SUBJECT: Duke Energy Carolinas, LLC (Duke Energy)  
McGuire Nuclear Station, Units 1 and 2  
Docket Nos. 50-369 and 50-370

Final Responses to NRC Request for Additional Information (RAI) related to  
Generic Letter (GL) 2004-02, "Potential Impact of Debris Blockage on  
Emergency Recirculation During Design Basis Accidents at Pressurized-Water  
Reactors"

**McGuire Nuclear Station  
Generic Letter 2004-02 Supplemental Response  
November 18, 2008 NRC RAI  
Final Response**

**Figure 13S-1: Top Hat Strainer Module Submergence  
Vortex Test Condition**

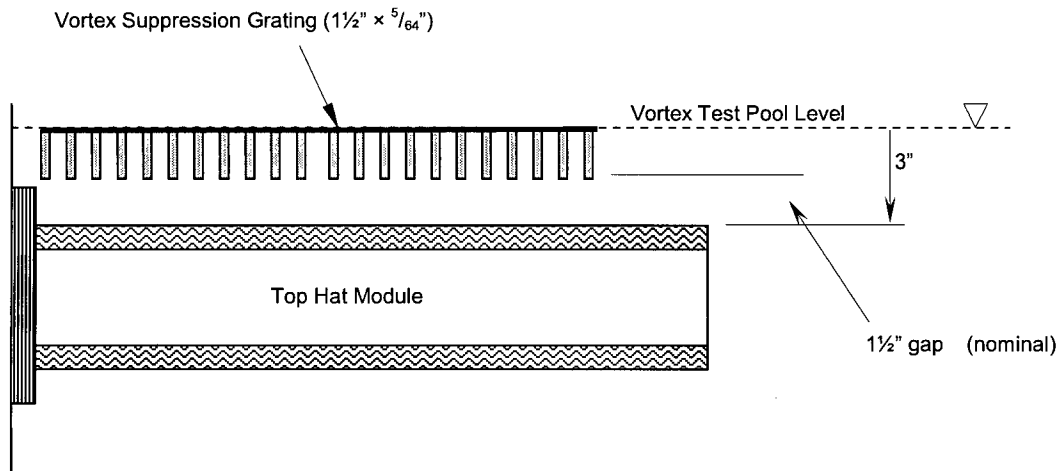
13. The conditions under which vortex testing was conducted for McGuire, and the plant conditions for which the testing was being conducted, are not clear from the available documentation. Based on the information provided to date, the NRC staff has been unable to determine what conditions resulted in vortex formation and whether the modifications made to eliminate vortices were tested under conditions that conservatively represented those expected in the plant post-LOCA. Vortex testing was conducted at 3-inch submergence (as stated in the Duke Energy Carolinas (Duke) response to RAI question 39 in Enclosure 1 to the supplemental response dated February 28, 2008), which is greater than the expected 2-inch minimum submergence for a small break loss-of-coolant accident (SBLOCA) (as stated in Section 3(f)(2) of Enclosure 2 of the supplemental response). Note that Duke further states in its response to RAI question 39 in Enclosure 1 that the minimum submergence for the strainer is expected to be "at least" 2 inches and separately that it is "about" 4 inches (Enclosure 1, pages 35-36). Enclosure 2, Section 3(f)(2), also states that the strainer is submerged by at least 2 inches while Enclosure 2, Section 3(f)(3), states that the grating is submerged by at least 2 inches. Enclosure 2, Section 3(f)(3), also states that the testing was performed with a "few inches" of submergence. This set of disparate strainer submergence values does not provide a coherent description of the test conditions.

Enclosure 2, Section 3(f)(3), states that the testing was conducted at velocities between 0.01 ft/sec and 0.09 ft/sec, while the maximum approach velocity for the strainer is 0.052 ft/sec. The response does not provide a basis for the 0.052 ft/sec, other than the expected maximum approach velocity is greater than nominal by about a factor of 2 (Enclosure 1, pages 35-36), and does not clearly state that testing at or above 0.052 ft/sec did not result in vortices.

Please provide information that describes the conditions expected in the plant and those present during testing, including the following information:

- a. Please clarify what the actual minimum submergence for the strainer is expected to be in the plant.
- b. If different evaluations for vortexing were conducted for SBLOCAs and large break loss-of-coolant accidents (LBLOCAs), please provide details for each evaluation.

- c. Please provide the basis for the maximum approach velocity.
- d. Please provide a quantitative value for the approach velocity during which vortices were observed to form when no vortex suppressors were installed.

- e. Please provide a quantitative value for the submergence level at which the testing was conducted with no vortex suppressors installed. If the level changed (e.g., between SBLOCA and LBLOCA tests), please provide the test conditions for each test.

- f. Please provide information for testing that was conducted with the vortex suppression grating in place, including the minimum submergence and maximum approach velocities that were present when vortices did not occur.

- g. Provide a quantitative value for the vortex suppressor submergence in the reactor plant. If some suppressors are installed at different elevations than others, provide the submergence level for each location.

Refer to Figures 13S-1 and 13S-2 below for the responses to questions (a) through (g).

- b. Vortex evaluations were performed for the McGuire ECCS Sump Strainer design for the limiting submergence level (SBLOCA scenario) only. The testing was performed at a submergence level of three inches, which is less than the minimum predicted SBLOCA submergence level of  $\geq 4$  inches, and therefore conservative. The LBLOCA scenarios generate more pool volume and a higher submergence level. Details regarding the SBLOCA vortex evaluation are located in the McGuire GL 2004-02 Supplemental Response dated February 28, 2008, Enclosure 2, item 3(f)3.

- d. Vortex suppression testing was performed in two parts; neither portion used walls to model the adjacent top hats or base plates, as the walls could artificially still vortex formation. Water level was set to 3 inches above the topmost surface of the perforated plate of the strainer (reference Figure 13S-1). Vortex testing was performed by initially establishing flow at 0.01 feet per second for a time of 10 minutes; without a vortex suppressor installed, and then increasing up to 0.06 feet per second, in increments of 0.01 feet per second. Subsequently, additional testing was performed starting at an approach velocity of 0.06 feet per second and then increasing up to 0.09 feet per second, with the same increments and hold times. At approach velocities at and above 0.04 feet per second, an air-entraining vortex was present. When the vortex formed, the vortex suppressor grating was installed in the designated location (i.e., leaving a 1.5-inch gap between topmost surface of the strainer module and the bottom of the vortex suppression grating). Efficacy of the suppressor was demonstrated by elimination of the vortex at all approach velocities up to 0.09 feet per second with only minor surface dimpling remaining.

- e. Referencing Figure 13S-1, the submergence level of the strainer top hat module topmost surface (perforated plate) during the vortex suppression testing was fixed at 3 inches. The vortex testing did not vary the submergence for LBLOCA/SBLOCA; the submergence level

**Figure 30S-1: McGuire ECCS Sump Strainer (typical)**

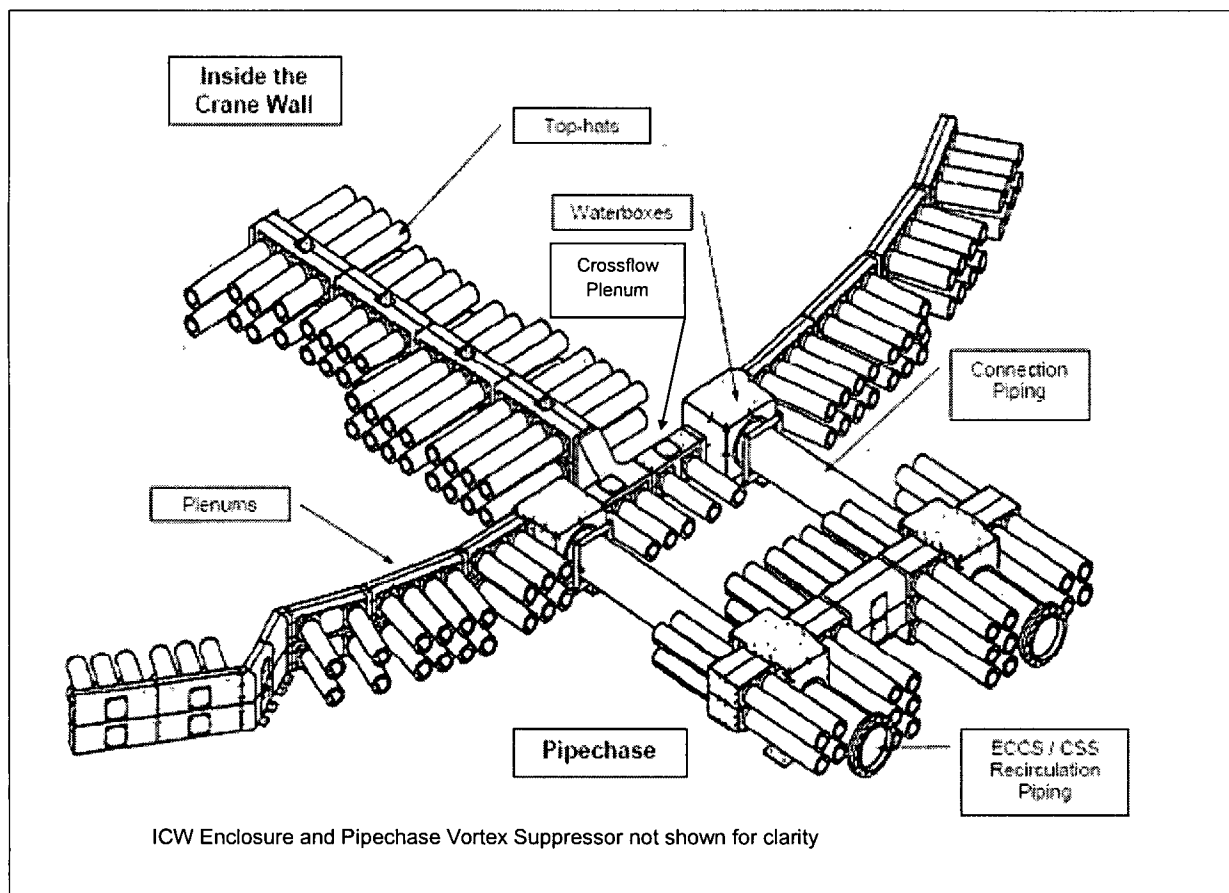
RAI question 30: Identified the Crossflow Plenum of the ECCS Sump Strainer in Figure 30S-1, and added note regarding the use of faulted allowable loads based on NRC feedback from November 1, 2010 teleconference.

As described in the McGuire GL 2004-02 Supplemental Response dated February 28, 2008, the ECCS Sump Strainer is constructed of robust materials and is positioned both inside and outside the crane wall (see Figure 30S-1).
